平陆县 100MW 农光互补光伏发电项目

监理工程师通知单

编号: ZHJL-JLTZ-PL-147

2024 年 10 月 28、10 月 29 日建设单位、监理单位及总包单位对东郑 11、10 区光伏区验收过程中发现以下问题:

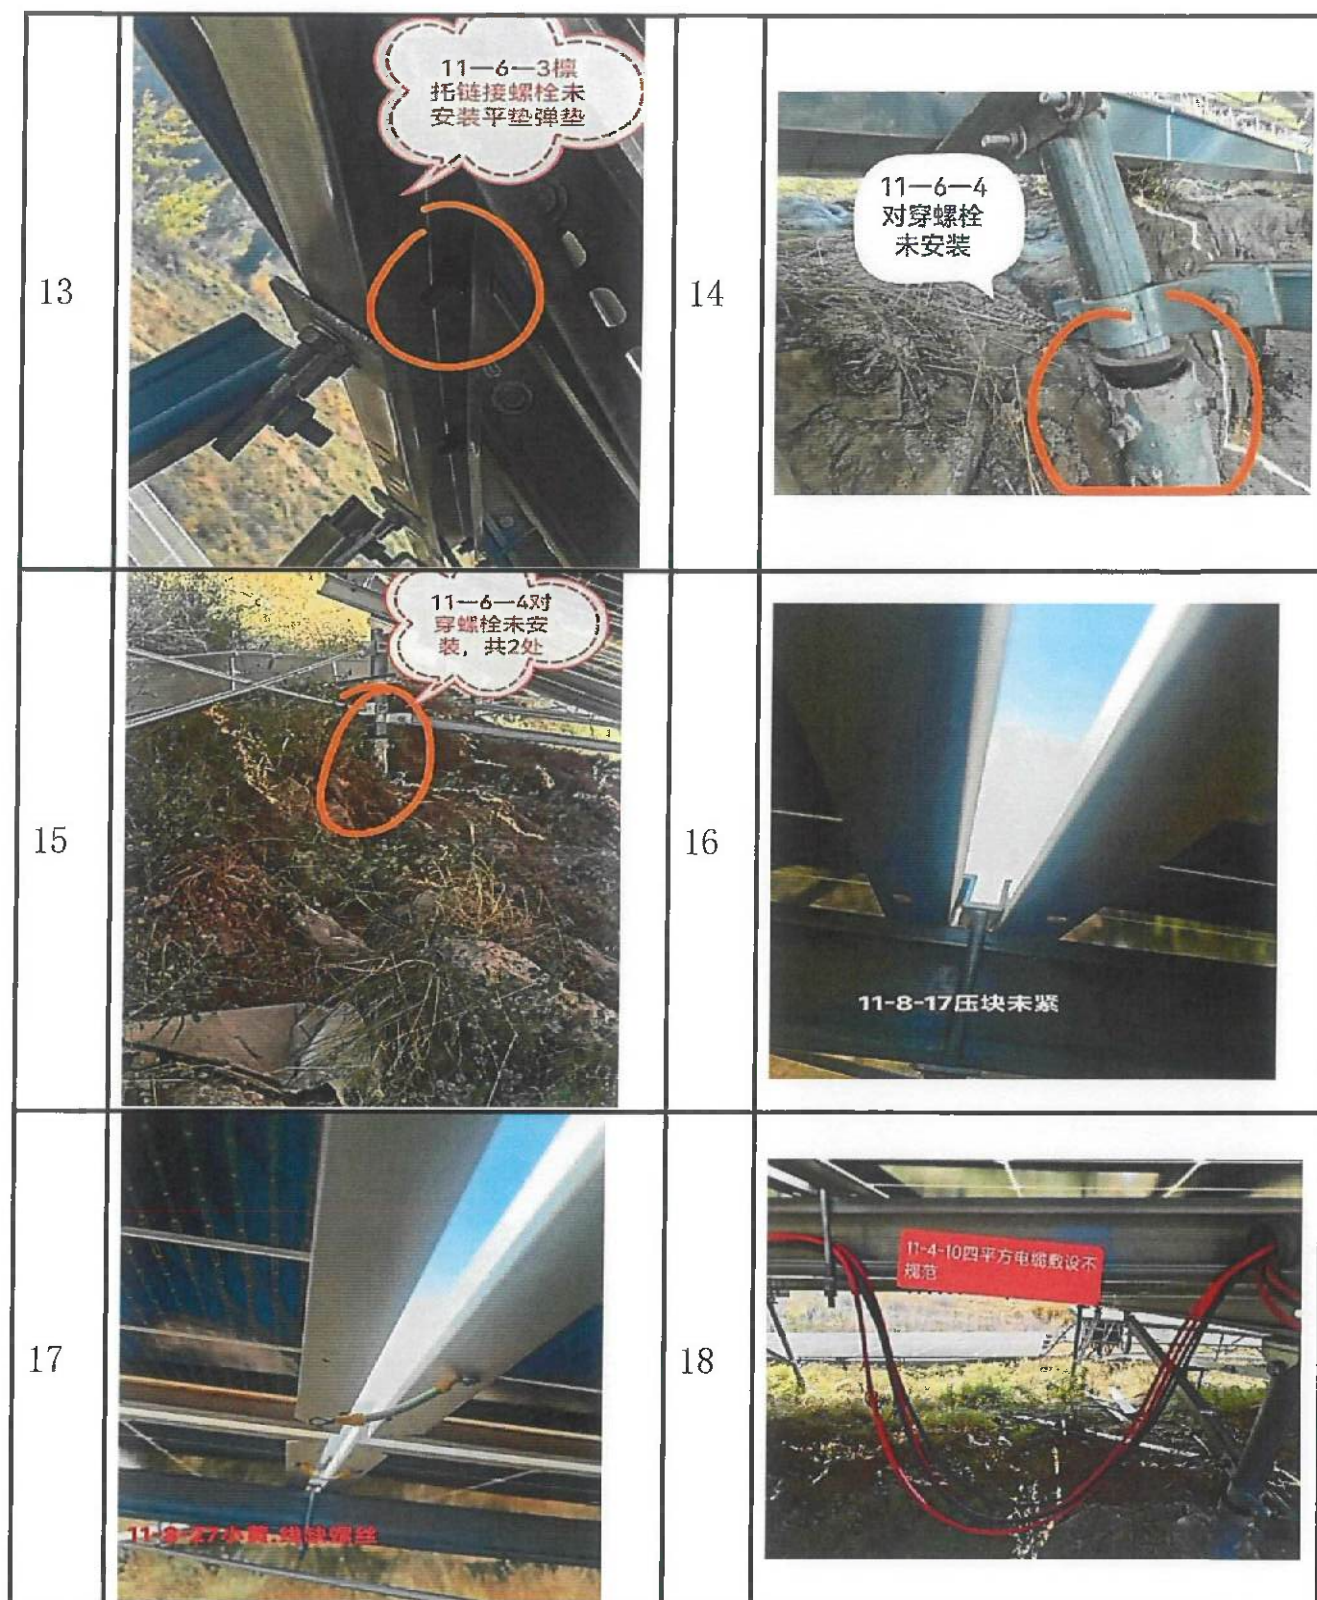
5	 11-6-2 撑托缺弹 垫	6	 11-4-22 地埋桩没有 浇筑桩帽
7	 11-6-3 多余压块 拆除	8	 11-4- 23桥架盖 板未清理
9	 11-5- 24对穿螺 栓未安装	10	 11-5- 24压块滑 丝需更换
11	 11-5- 23对穿螺 栓未安装	12	 11-6-3 对穿螺栓 未安装

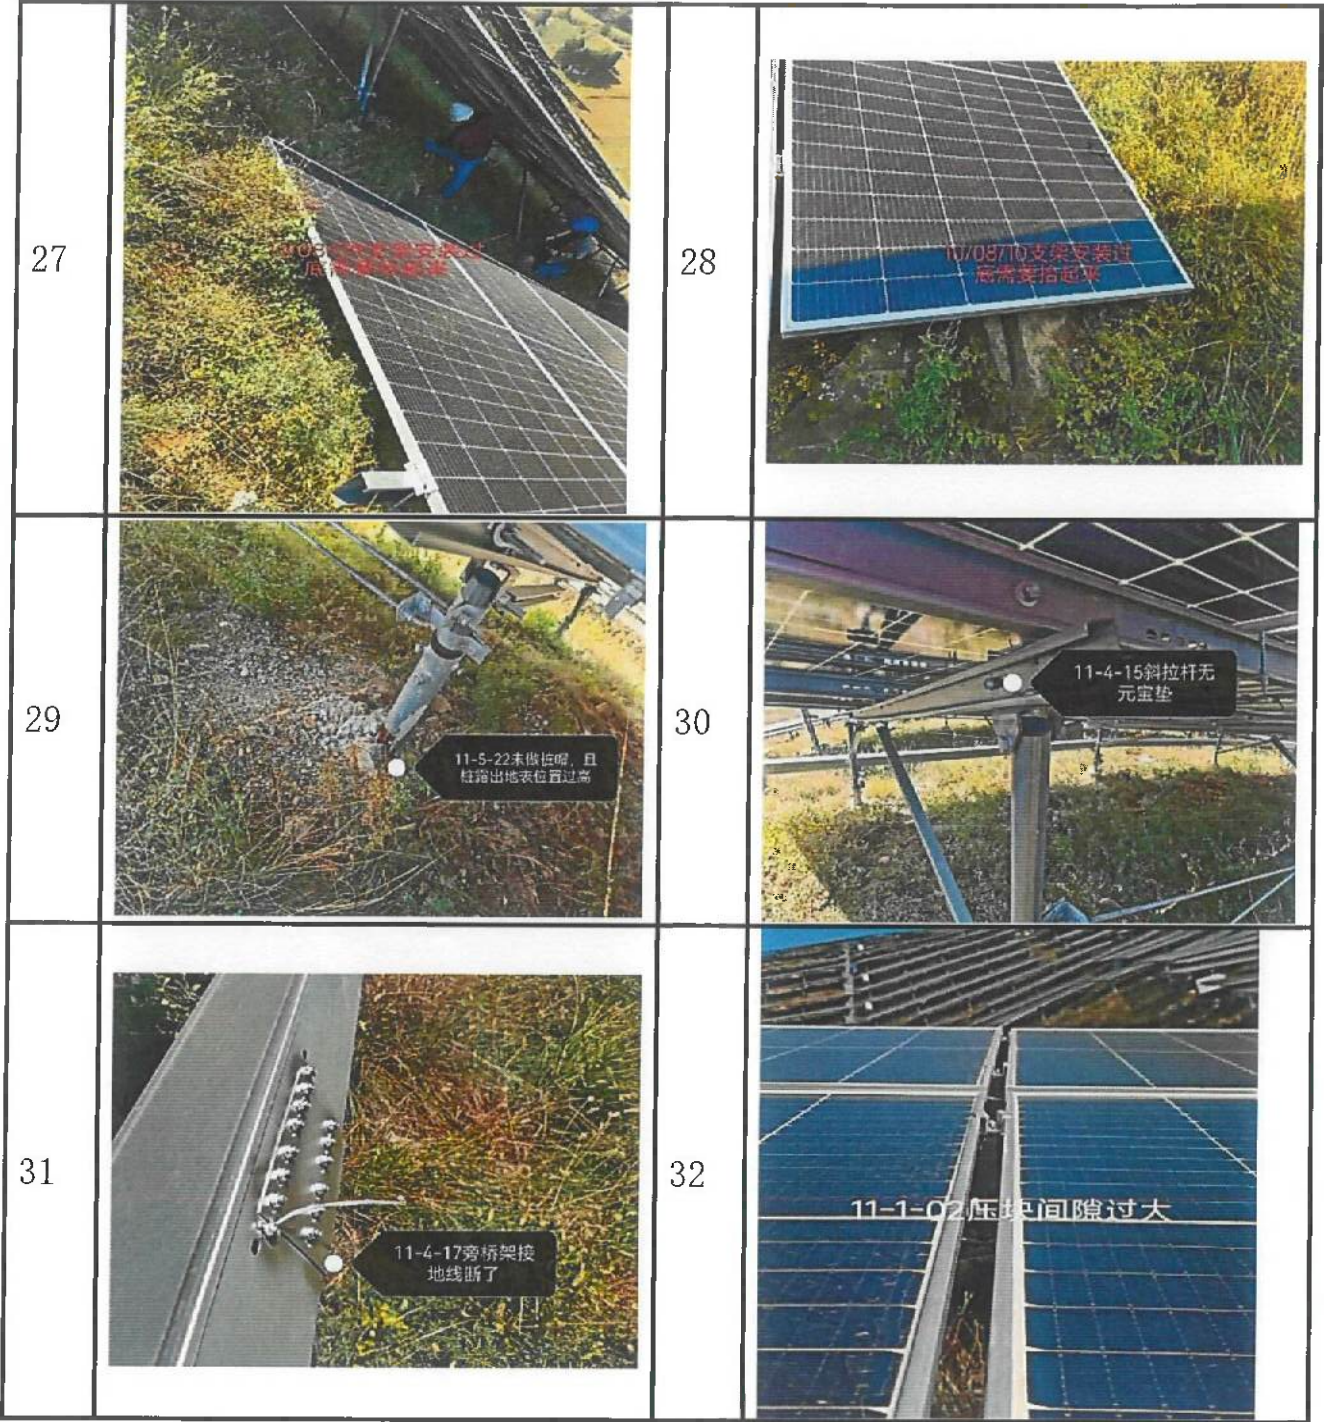
19	 11-4-9四平方线套管未绑扎	20	 11-4-13拉杆安装不规范
21	 11-4-9缺少对穿螺栓	22	 11-6-18压块受力面小，需要调整
23	 11-6-20斜撑需要调整	24	 11-6-19至11-6-18间接地为连接
25	 11-6-25拉杆需要更换	26	 11-8-5多余压块

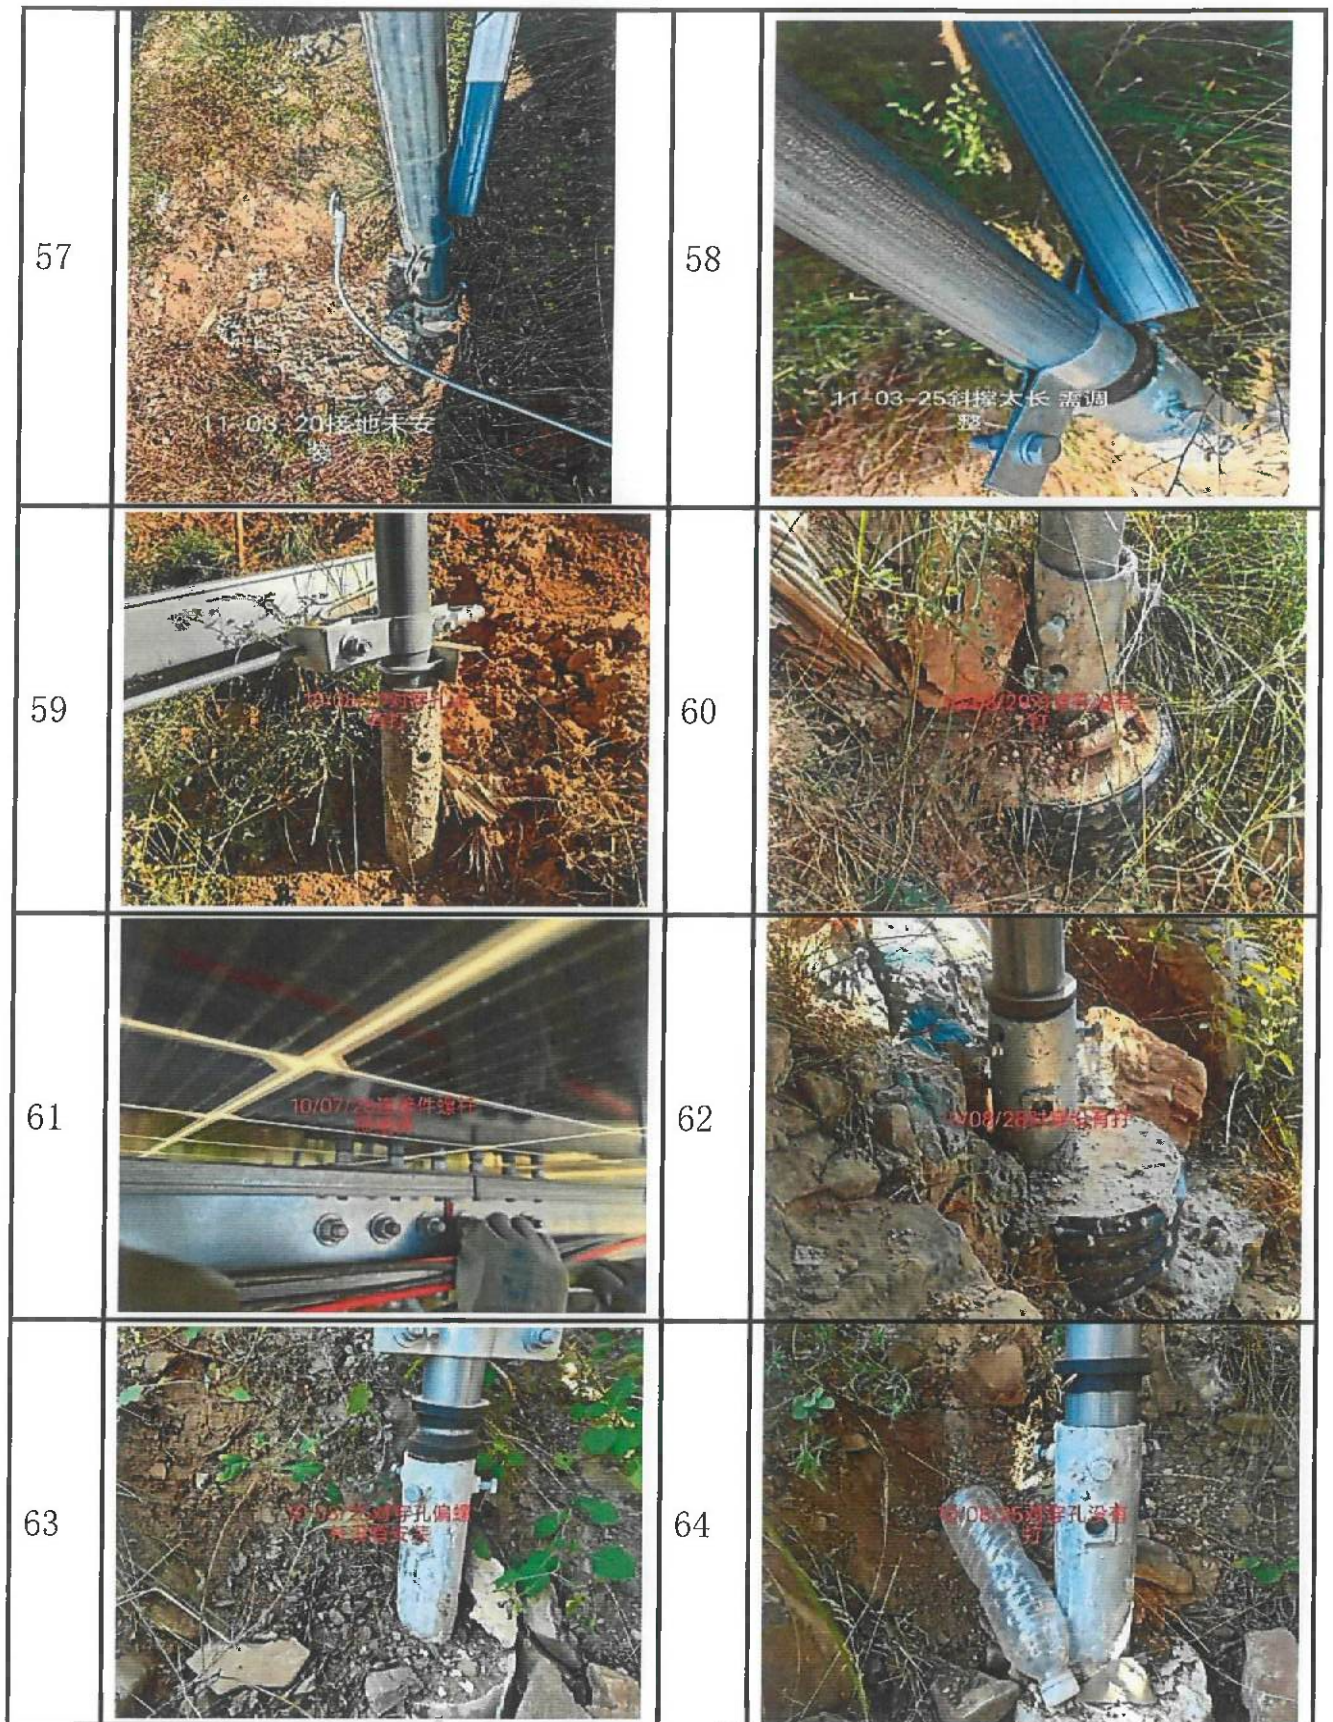
65	 10/08/21 5吋管孔塞	66	 10/08/21 5吋管孔塞
67	 10/08/22 斜撑没安装	68	 10/08/22 斜撑不受力 2个
69	 10/08/21 斜撑不受力 2个	70	 10/08/22 缺少对穿

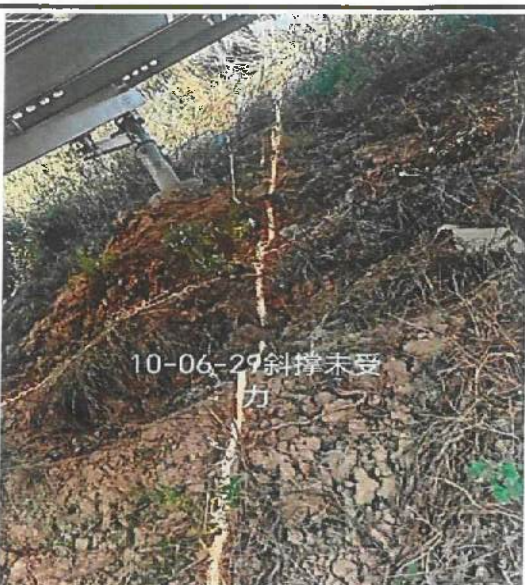
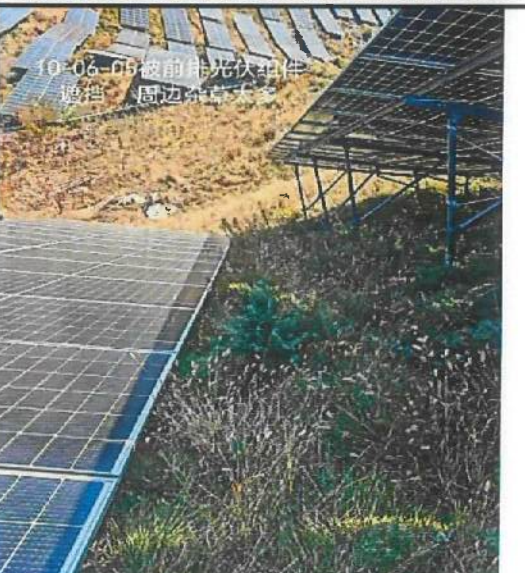
83	 10-06-25斜撑未受力	84	 10-06-29斜撑未受力
85	 10-06-14线前排光伏组件遮挡， 光伏组件周边杂草太多	86	 10-06-05线前排光伏组件 遮挡，周边杂草太多
87	 10/06-02光伏组件损坏破裂	88	 10-1-4前立杆缺少对穿螺栓

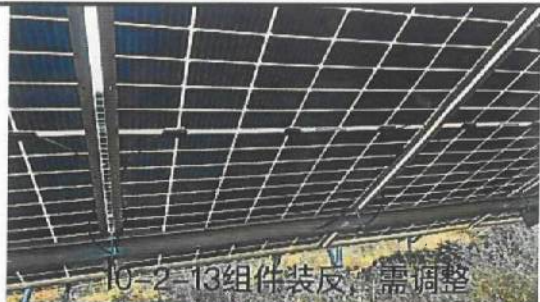
89	 10-1-2背拉杆需更换	90	 10-2-13组件装反，需调整	
91	 10号方阵东侧需要清表	92	 10-5-16寒刺遮挡组件	
93	10-4-9, 10-4-10 组串正负极无号码管		94	 10-02-04对穿螺栓有上
